APPLICATION NO.	FILING DATE	FIRST NAMED INVENTOR	ATTORNEY DOCKET NO.	CONFIRMATION NO.
10/586,607	07/19/2006	Tetsuya Kohno	293159US3PCT	5945
22850	7590	08/19/2009		
OBLON, SPIVAK, MCCLELLAND MAIER & NEUSTADT, L.L.P. 1940 DUKE STREET ALEXANDRIA, VA 22314				
EXAMINER				
DIAZ, THOMAS C				
ART UNIT		PAPER NUMBER		
3656				
NOTIFICATION DATE		DELIVERY MODE		
08/19/2009		ELECTRONIC

Office Action Summary

DETAILED ACTION

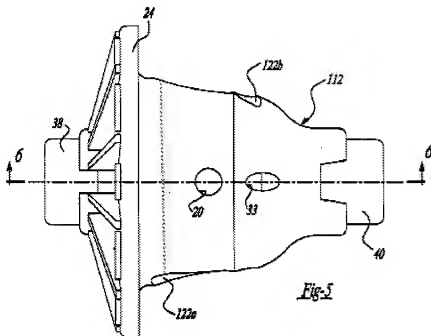
Regarding claim 22, Downs et al. discloses the opening further comprises a straight portion that is located closest to the output portion (fig.3, there is at least one very small straight portion located closest to the output portion; if one zooms into the

opening far enough there would be a straight portion), and wherein the straight portion is perpendicular to the longitudinal rotational axis of the differential gear casing (fig.3, there is at least one very small straight portion perpendicular to the rotational axis at a point where the corner 155c beings to develop).
